BCA Assessment Report

3 Holdsworth Avenue, St Leonards, NSW 2065

Reference No: 114507-BCA-r2.1

Date: 22 June 2022

Figure 2 - Rise in Storeys

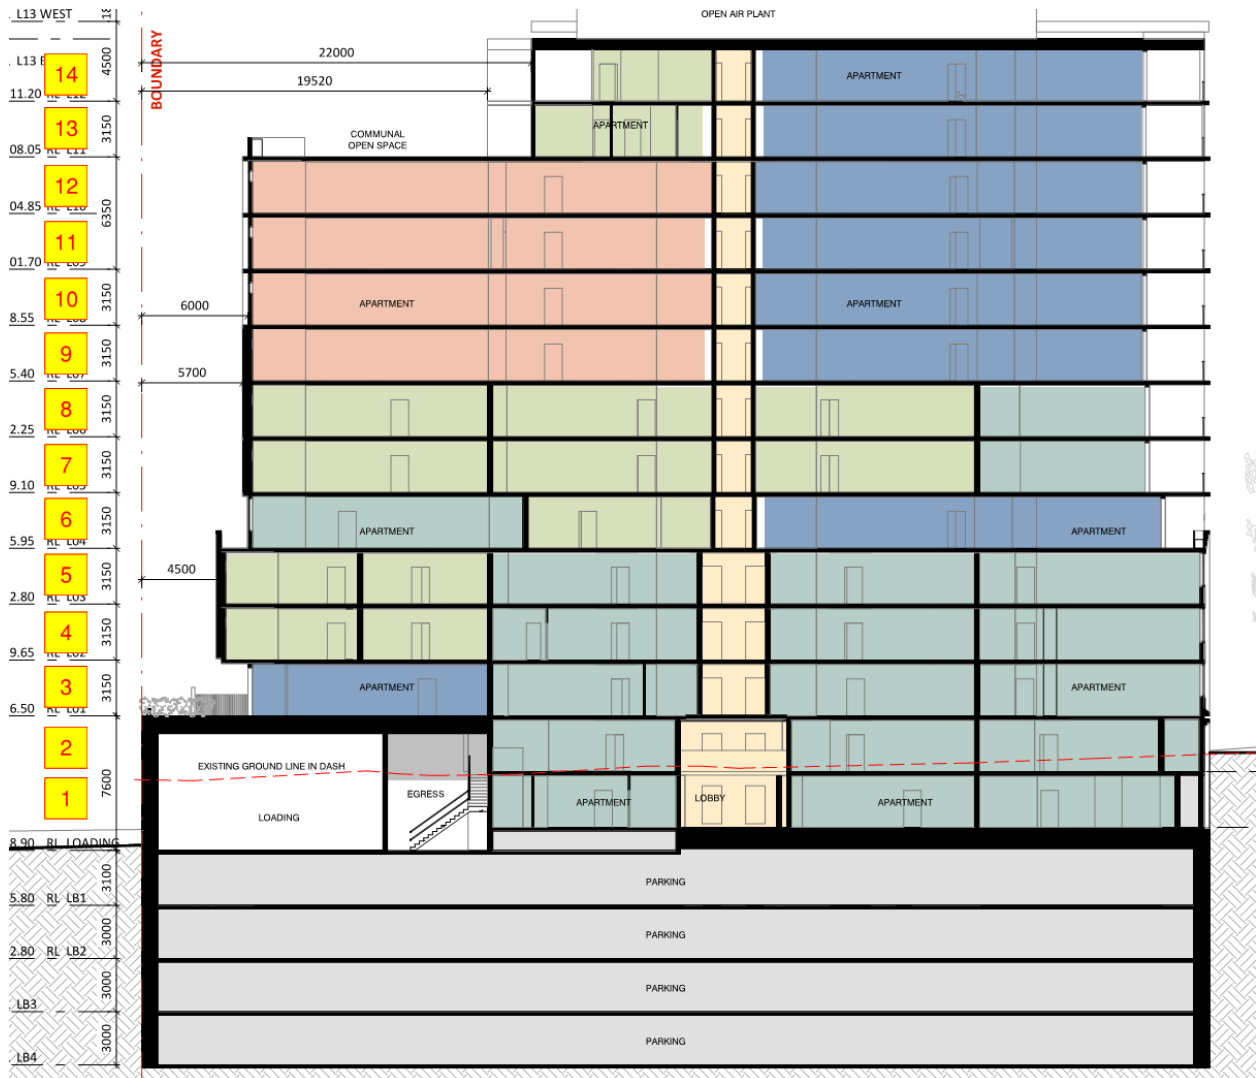
The building has a rise in storeys of fourteen (14).
